THE BOND JSP 18-10

Public hearing at the request of Bond at Novi LLC for JSP18-10 for recommendation to the City Council for approval or denial of the revised Preliminary Site Plan, Woodland Permit and Storm Water Management Plan. The revised plans propose to add a fifth floor to accommodate additional units.

Planning Review
The Bond fka The District
JSP 18-10

Revised Preliminary Site Plan

SITE PLAN REVISION

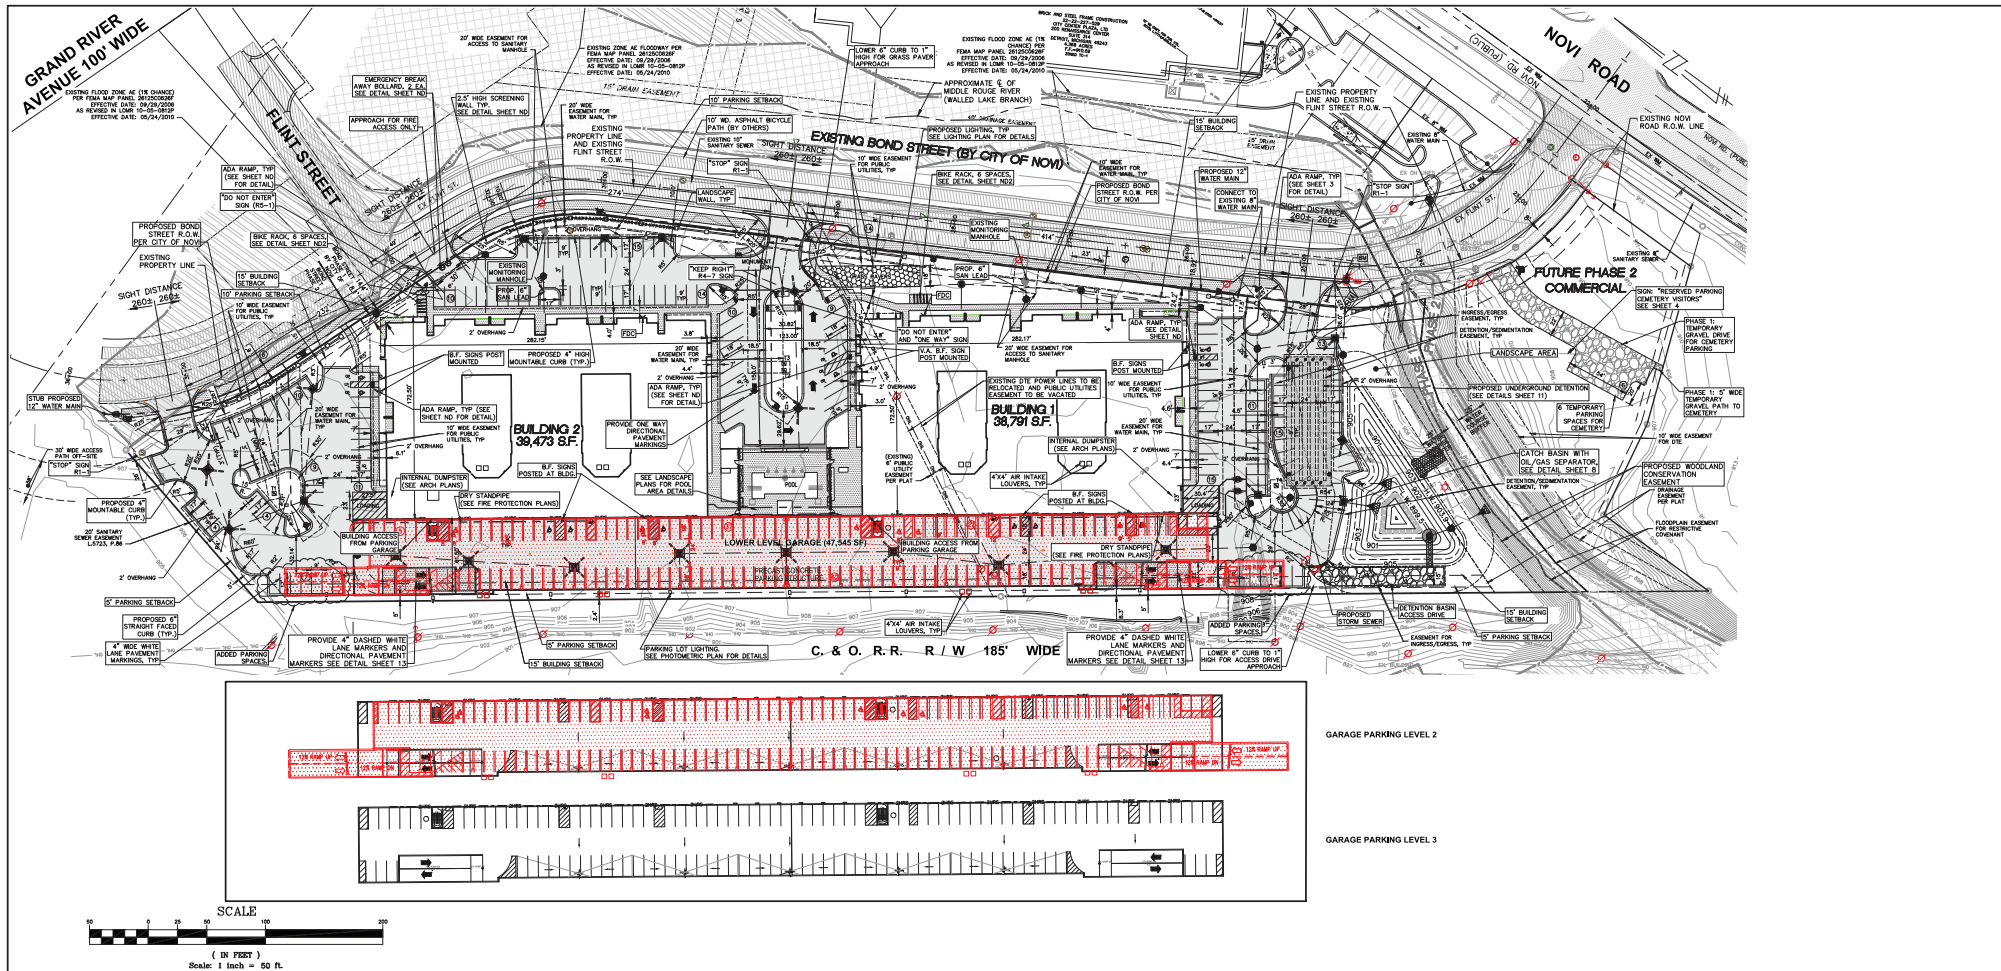
1. REVISED PARKING DECK TO 3 - LEVELS (ORIGINAL PARKING DECK SHOWN IN RED)

2. ADDED 14 SURFACE PARKING SPACES

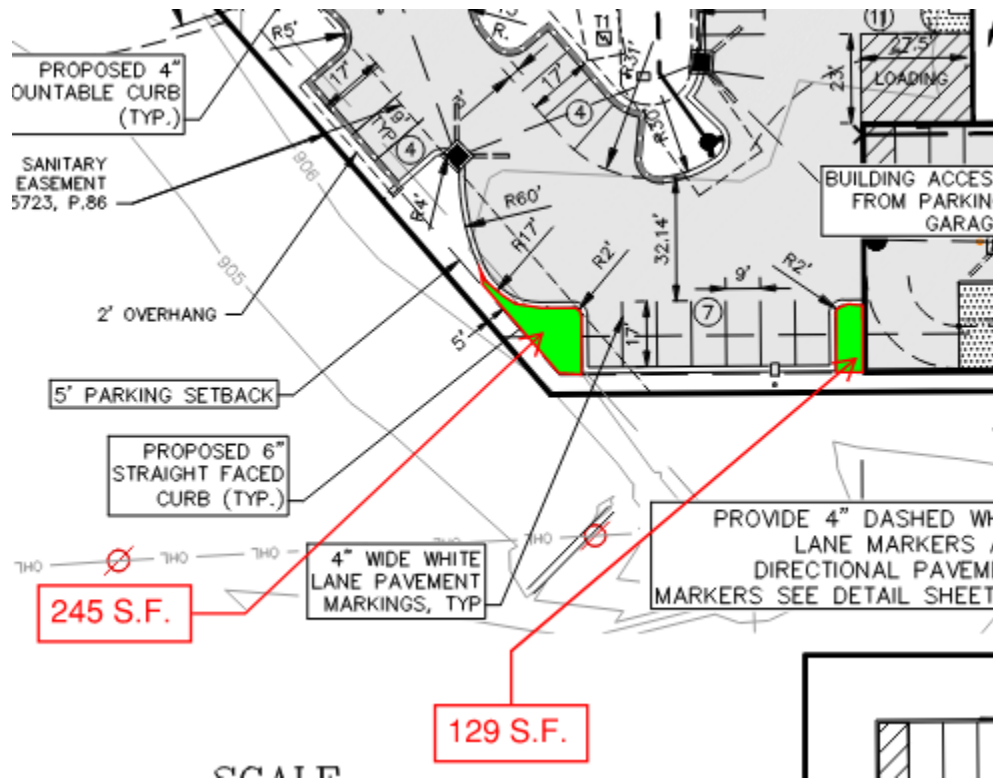
As requested in the Planning Review letter, the Landscape areas that will be revised have been marked up in red as follows:

Sheet L1.00: Removed 2 landscape islands at ends of parking structure. Added new parking spaces and landscaping areas at ends of parking structure. Please see Revised Site Plan for revised layouts in these areas.

Sheet L2.00: Close up view of the landscape island to be removed and new parking areas at the north end of the parking structure.

Sheet L2.02: Close up view of the landscape island to be removed and new parking areas at the south end of the parking structure.

The overall landscape calculations will be revised at Final Site Plan. Removing the two landscape islands at the ends of the parking structure results in a loss of Landscape Area of **367 sq. ft.** Adding the new parking and landscape areas results in an increase in Landscape area of **503 sq. ft.** The net result is a gain in landscape area of + 136 sq. ft. with the revised parking structure.

New Parking and Landscape Areas North of the Parking Structure:

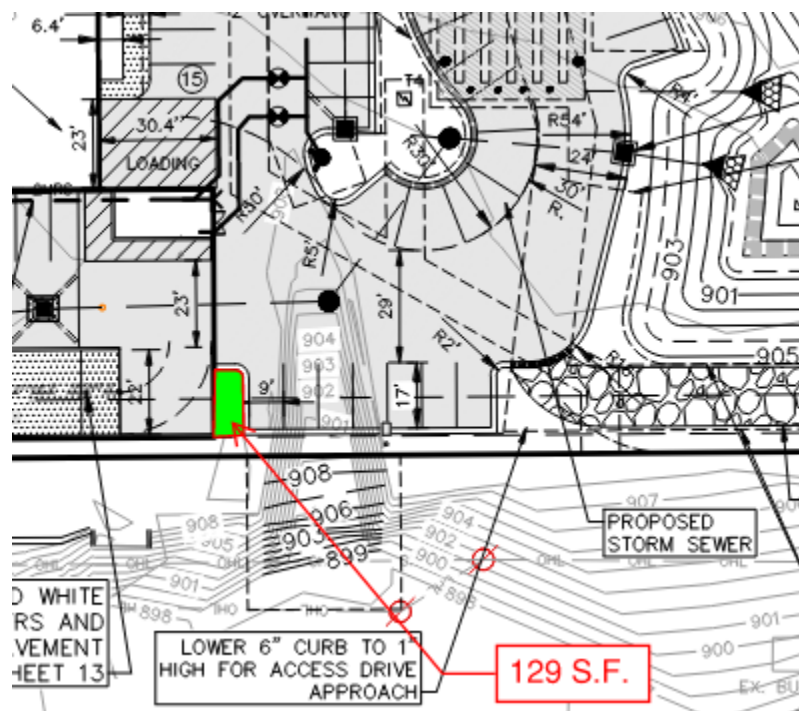
It was noted by the Planning and Landscaping reviewers that the new landscape areas adjacent to the parking decks may be inadequately sized. These landscape areas can be increased in size by removing the adjacent parking space. This revision will be included in the Final Site Plan submittal, if required.
